**RESPONSE TO THE OAK RIDGE SITE SPECIFIC ADVISORY BOARD  
RECOMMENDATION ON THE FACT SHEET FOR THE EXPLANATION OF  
SIGNIFICANT DIFFERENCES FOR THE RECORD OF DECISION FOR DISPOSAL  
OF COMPREHENSIVE RESPONSE, COMPENSATION, AND LIABILITY ACT  
WASTE, OAK RIDGE, TENNESSEE**

### **Explanation of Significant Differences for Expansion of the DOE-ORR Environmental Management Waste Management Facility (DOE/OR/01-2426&D1, November 2009)**

Figure 1. Aerial Photograph of EMWMF Site.

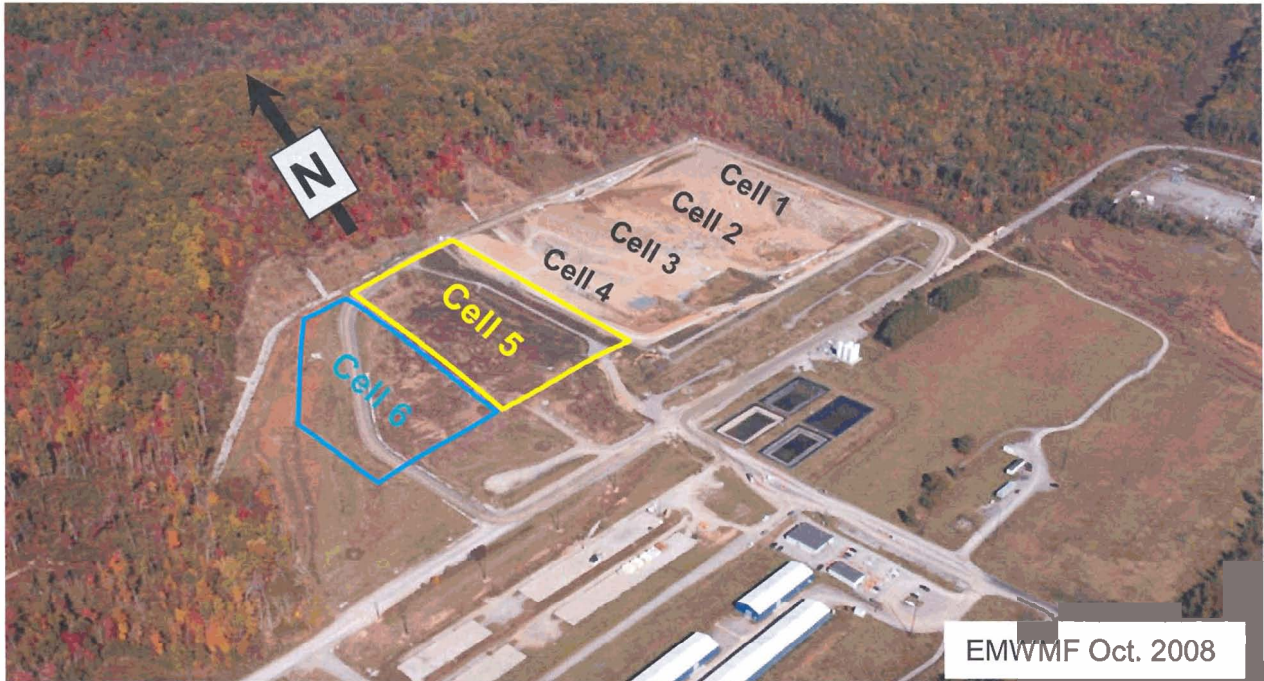
We have replaced the drawing of the EMWMF Cell 6 conceptual design and facility layout with a site plan illustration to address the board's concerns about the legibility of the illustration. We have also placed the aerial photograph and illustration on separate pages to improve legibility.
